**CALIFORNIA COASTAL COMMISSION**

**STAFF REPORT: REGULAR CALENDAR****APPLICATION NO.:** 4-99-268**APPLICANT:** David Geffen**AGENT:** Susan McCabe**PROJECT LOCATION:** 22108 Pacific Coast Highway, City of Malibu; Los Angeles County.**PROJECT DESCRIPTION:** Construct a 46 foot long timber bulkhead with concrete caissons and a 48 foot long return wall on east property boundary to protect an existing two story residence. In addition, the project includes an offer to dedicate a new lateral public access easement.

SUBJECT: Coastal Development Project Review for Proposed Seawall at  
22108 Pacific Coast Highway, Malibu

FROM: Lesley Ewing

EXHIBIT NO. 3  
APPLICATION NO. 4-99-268  
Project Plan  
& Photo

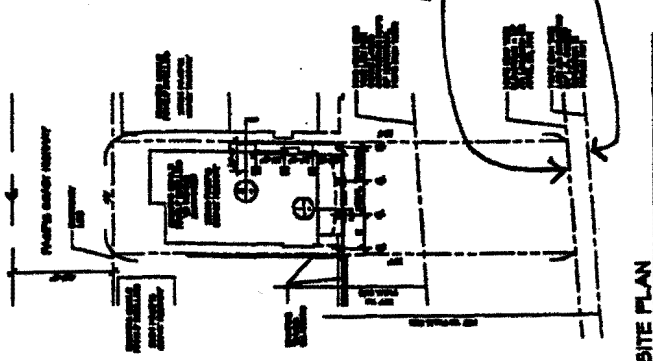
As proposed, this proposed bulkhead would extend seaward onto a sandy beach area approximately along a bowed deck area enclosing an area approximately 10 feet wide by 46 feet long (occupying about 460 sq. ft. of beach) beyond the existing residence structure and its supporting pilings. A portion of this sandy area is located beneath the cantilevered deck. It is important to note that the proposed project is not located on the landward portion of the beach as far landward as feasible. All projects requiring a coastal development permit must be reviewed for compliance with the public access and recreation provisions of Chapter 3 of the Coastal Act. Based on the access, recreation and development sections of the Coastal Act, the Commission has required
